# **Lilac Hills Ranch**

**Roundabout Peer Review by Reid Middleton**

**Roundabout Peer Review  
Exhibit of Findings  
October 2013**

Project Title:	W Lilac Rd Roundabouts	Design Phase (%):	Conceptual
Owner:	Accretive Investments, Inc.	Date:	October 25, 2013

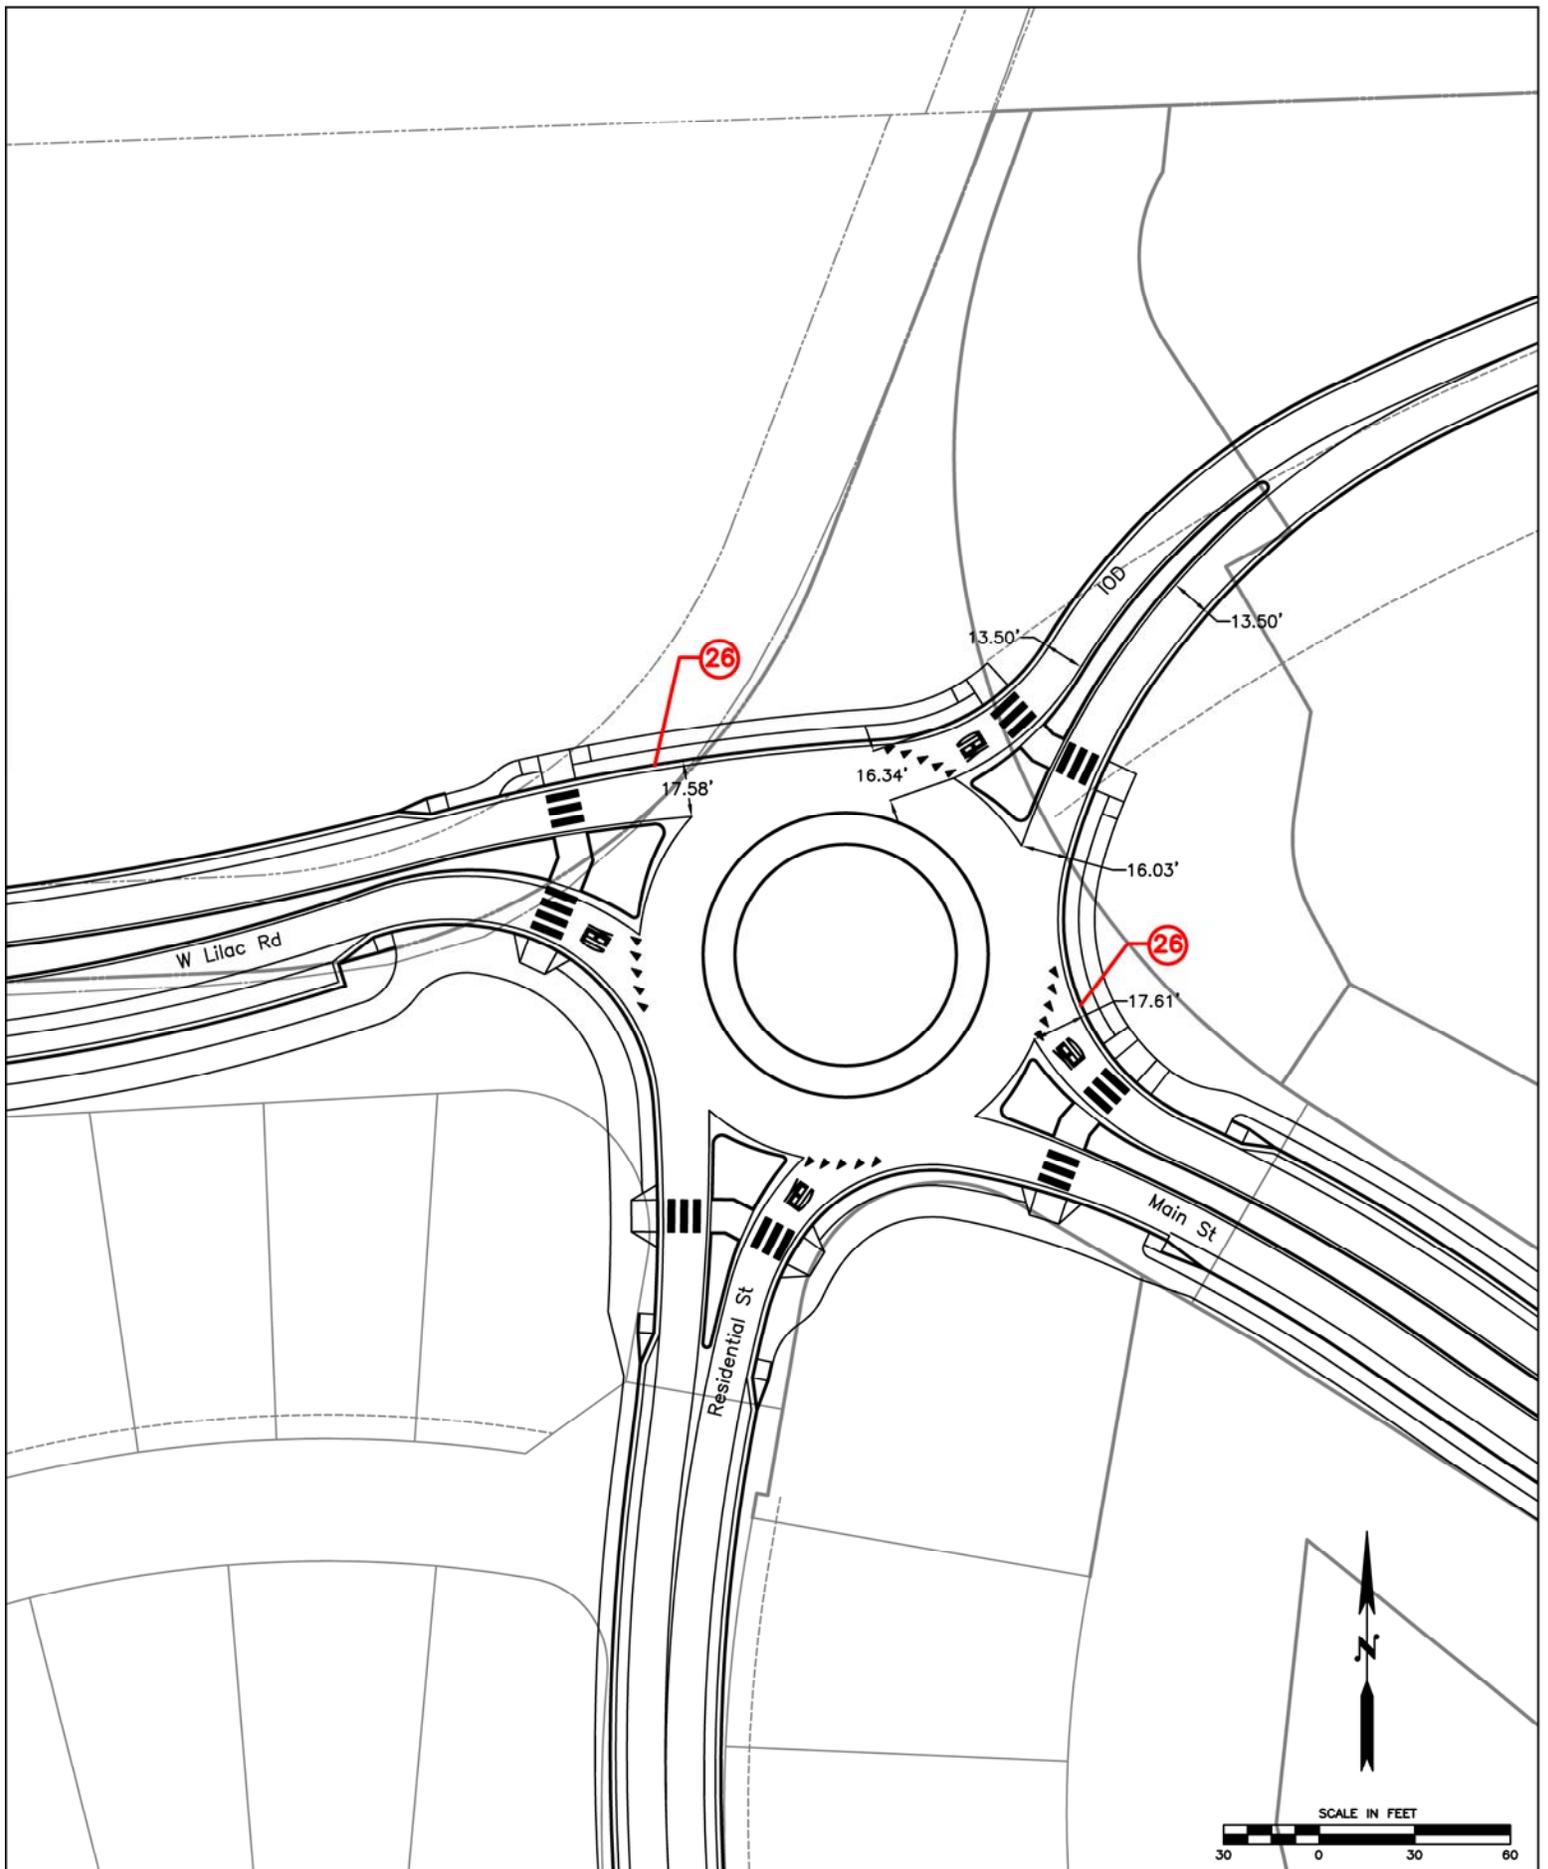
Item 26 (Figure 4)	Entry curvature on Main St and exit curvature on W Lilac Rd changed slightly to accommodate the proposed IOD alignment. All other curb locations remain the same as RB 1.

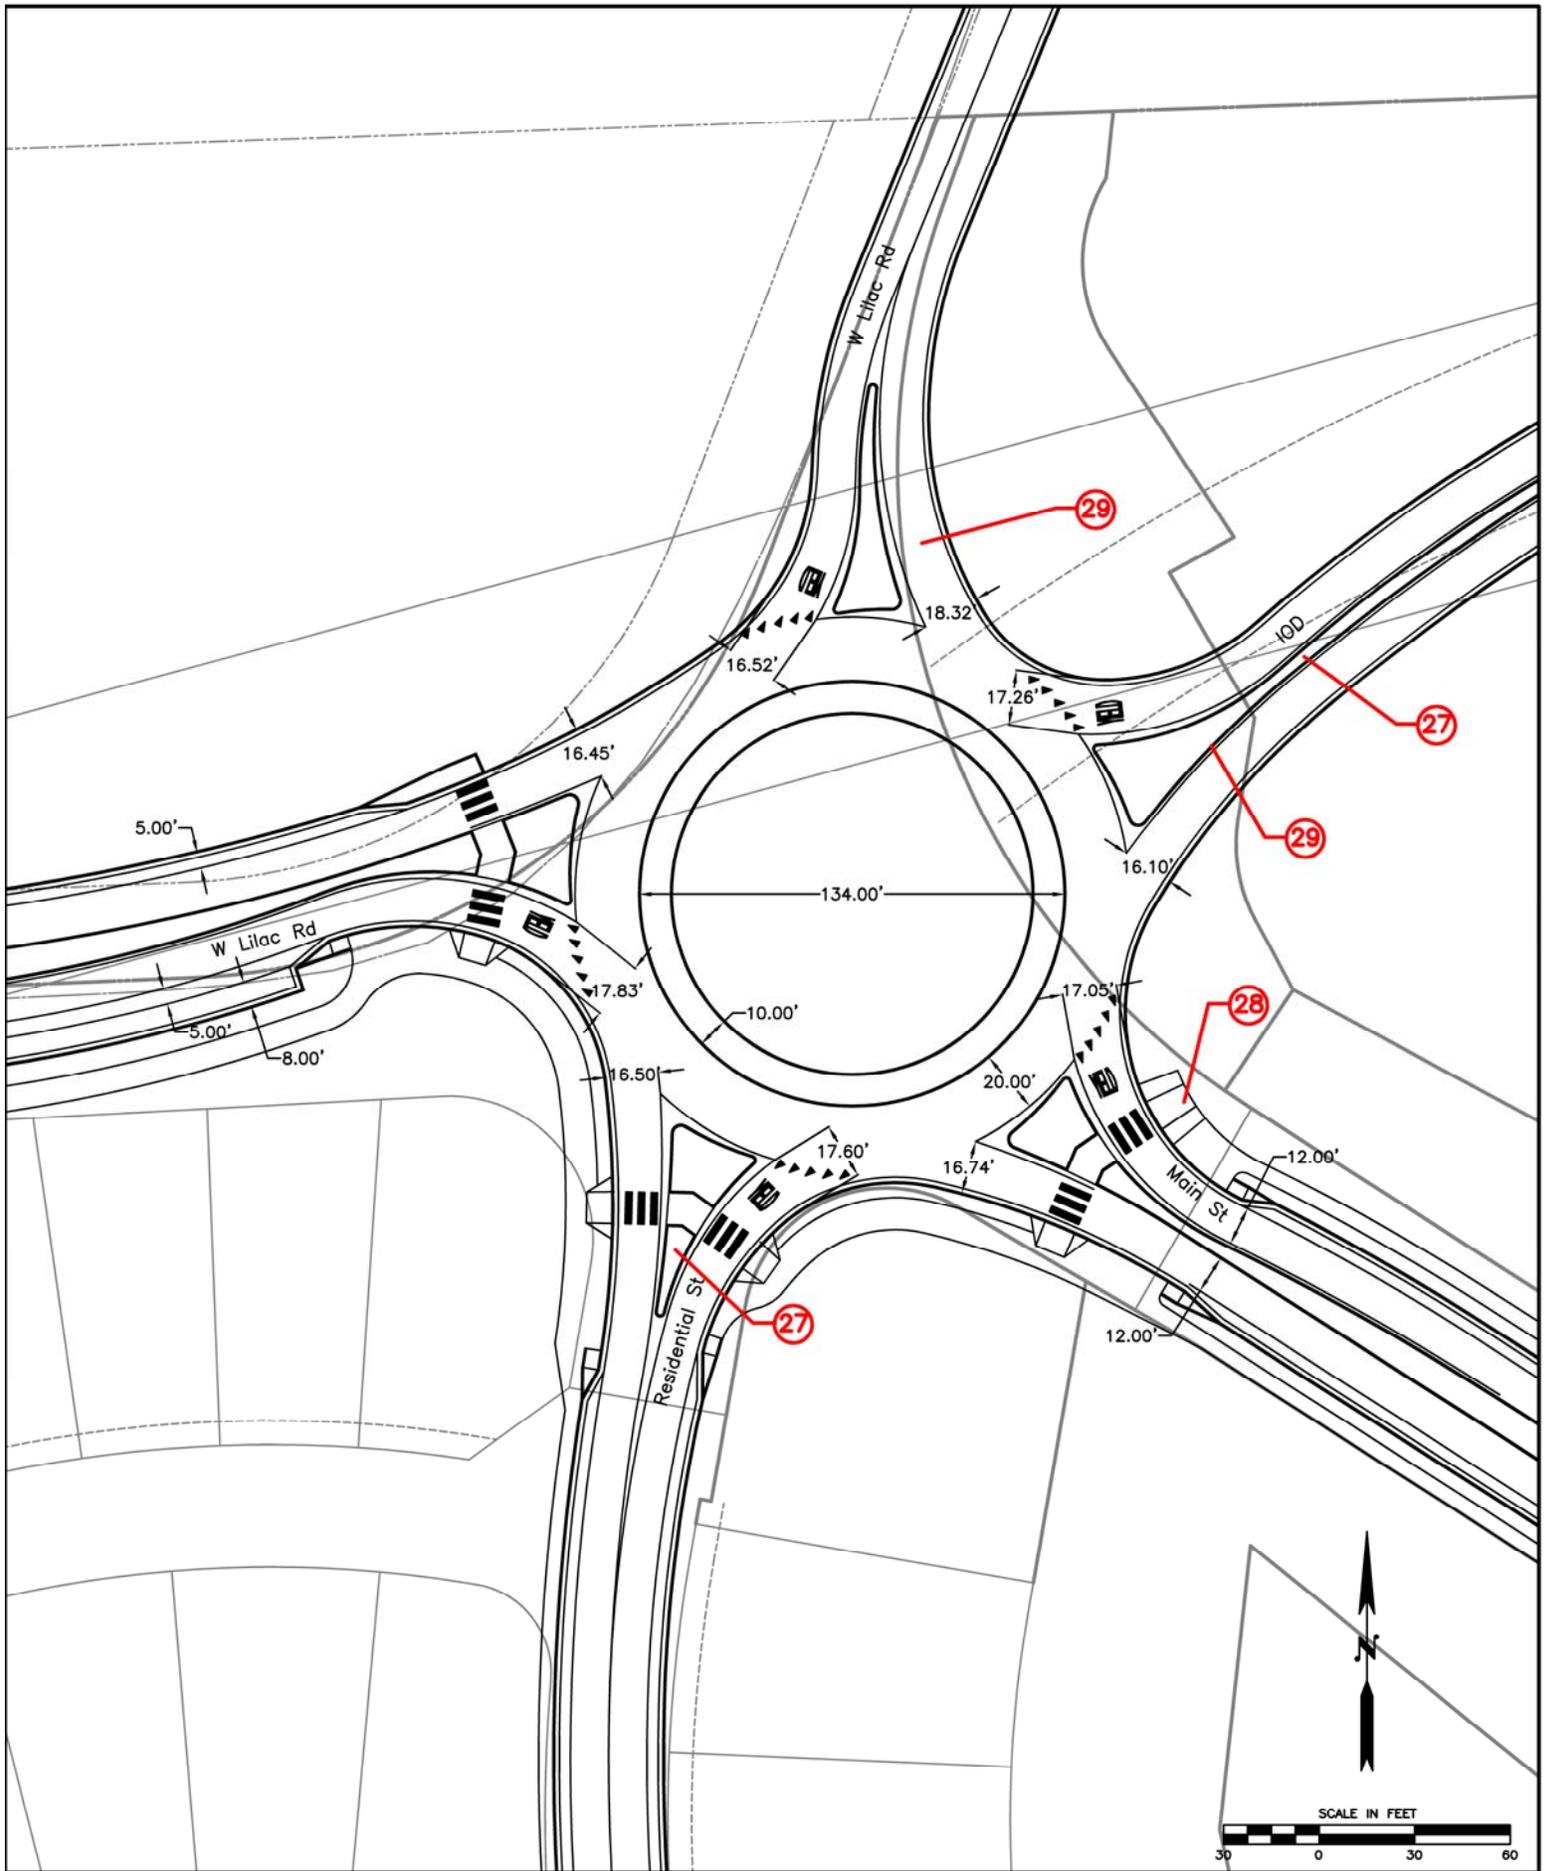
Item 27 (Figure 5)	The splitter island length is influenced by the approach speed. When the approach speed is 30mph a minimum splitter island length of 50ft is acceptable. At higher speeds, the splitter island length increases.

Item 28 (Figure 5)	This type of ramp was used to indicate that all multiuse path users should use this pedestrian crossing and subsequent multiuse paths. Bicyclists are encouraged to use the southern multiuse path system as this route does not substantially increase their crosswalk exposure.

Topic/ Reference	Comment
Item 29 (Figure 5)	This roundabout provides an excellent way of designing for the existing W Lilac Rd, but leaving options open for future IOD alignment development. Residents that live along W Lilac Rd will not have to be inconvenienced with a road closure, and they will not have a negative impact on the roundabout safety or operations. The IOD leg can be built at a later time with no impact to existing roundabout operations.
RM Design RB 2	RM designed a conceptual roundabout, RB 2 that addresses the above concerns of the second intersection. The following item nos. 30-31 correspond to the circular callouts on Figure 6. Appendix B contains all the corresponding back-up calculations for the horizontal geometrics of these RM conceptual roundabouts such as fastest paths, truck turning movements and sight distance requirements.

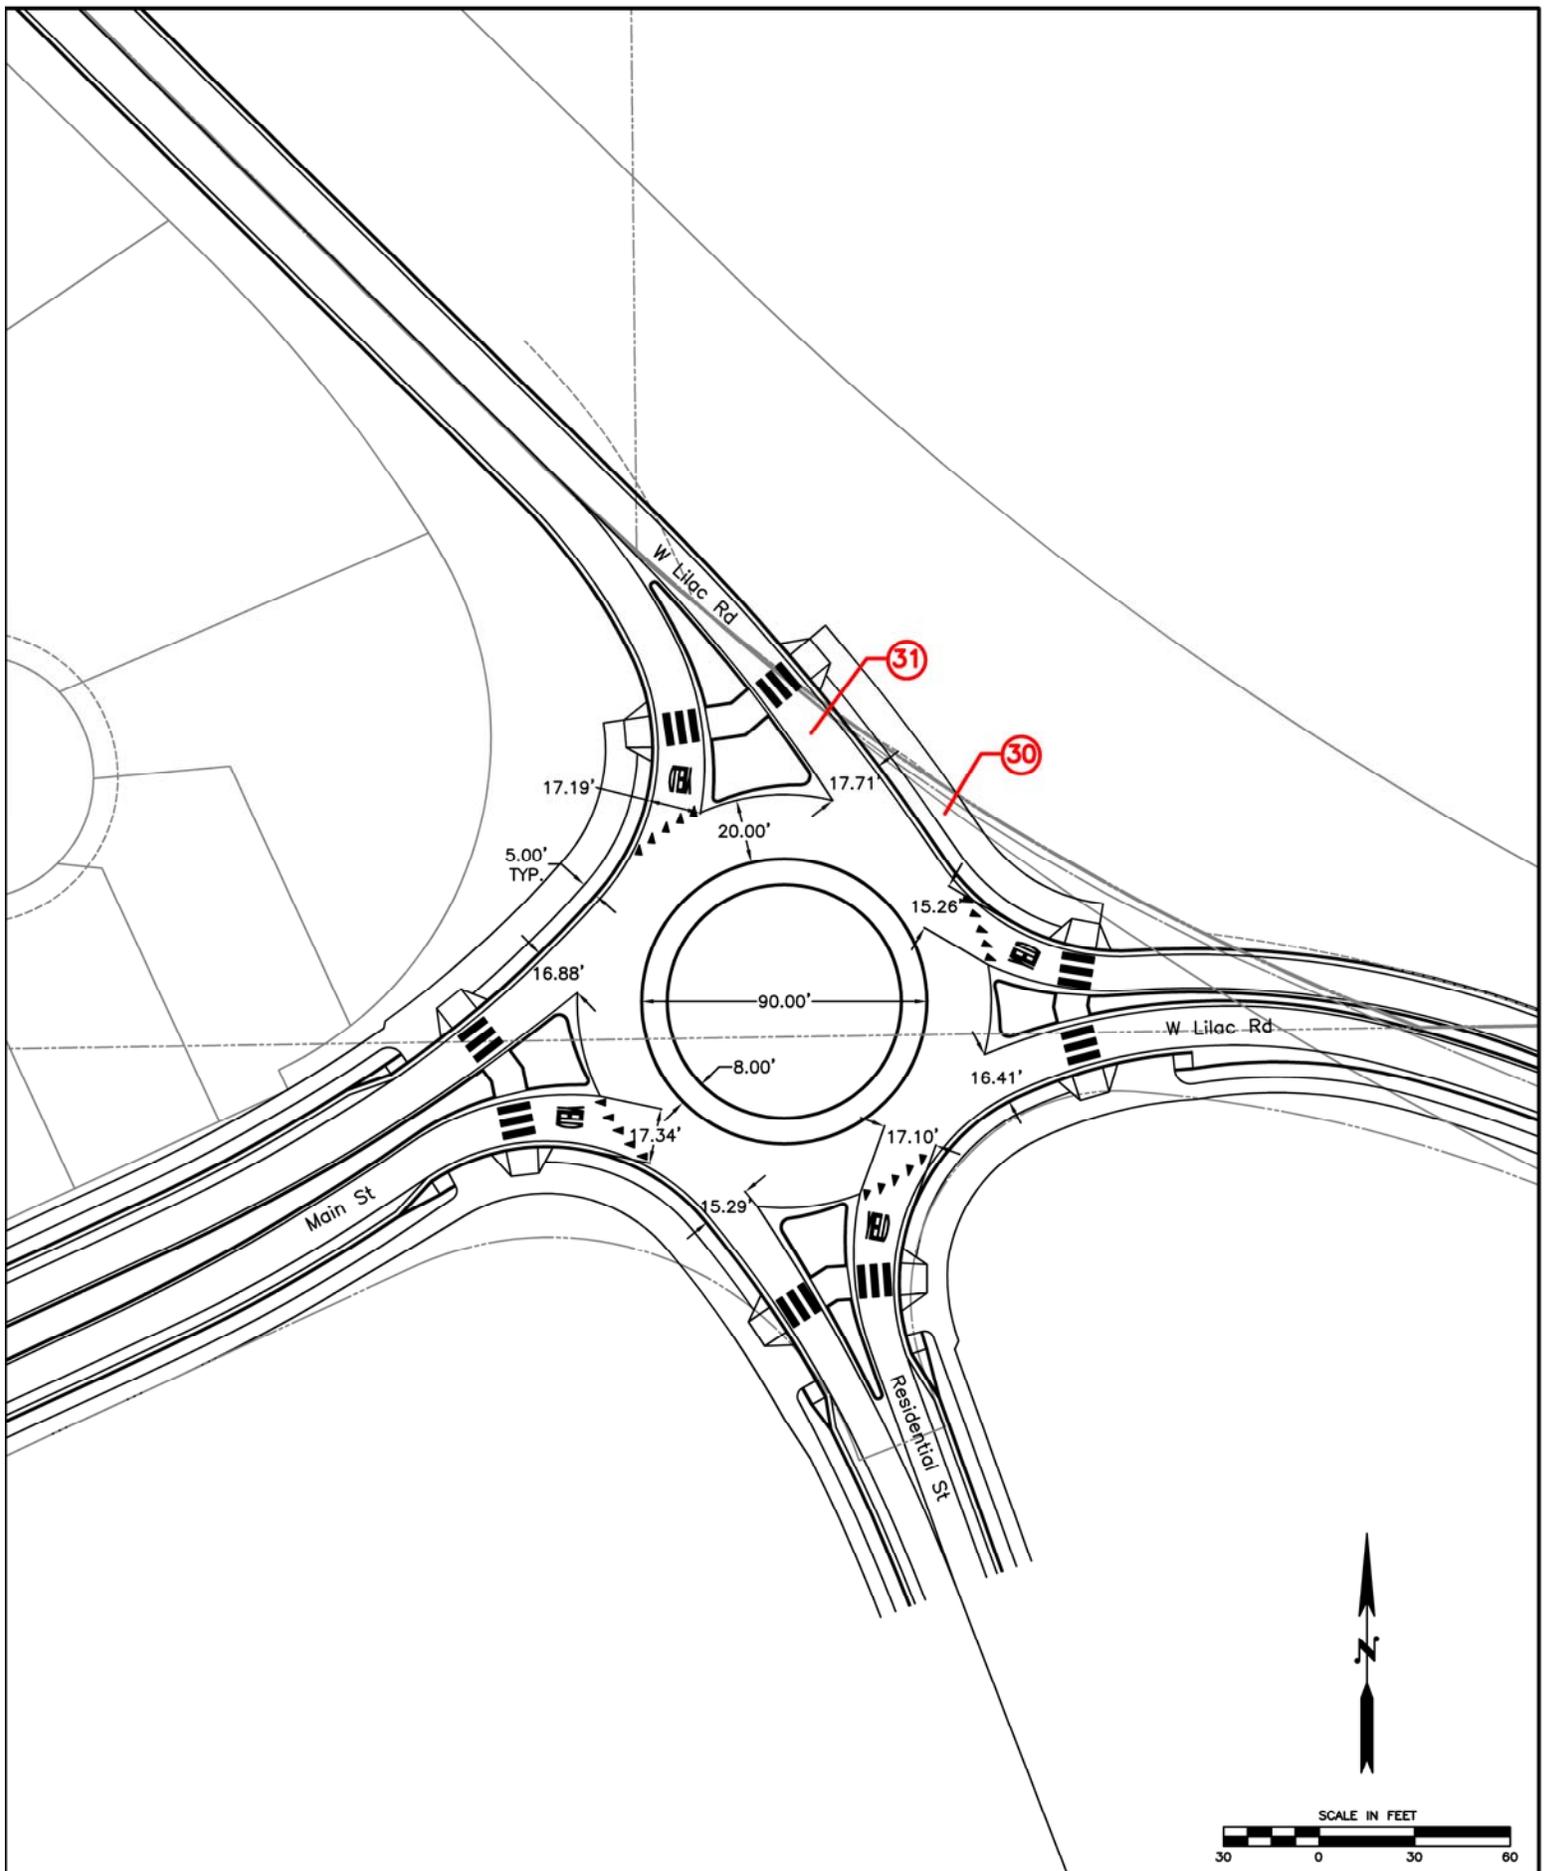
Item 30 (Figure 6)	Pedestrian facilities and corresponding crosswalk locations can be adjusted as needed based on proposed routes.
Item 31 (Figure 6)	Taking out the reverse curves on the W Lilac Rd exit (north leg) allows for a more natural vehicle path as cars exit the roundabout.
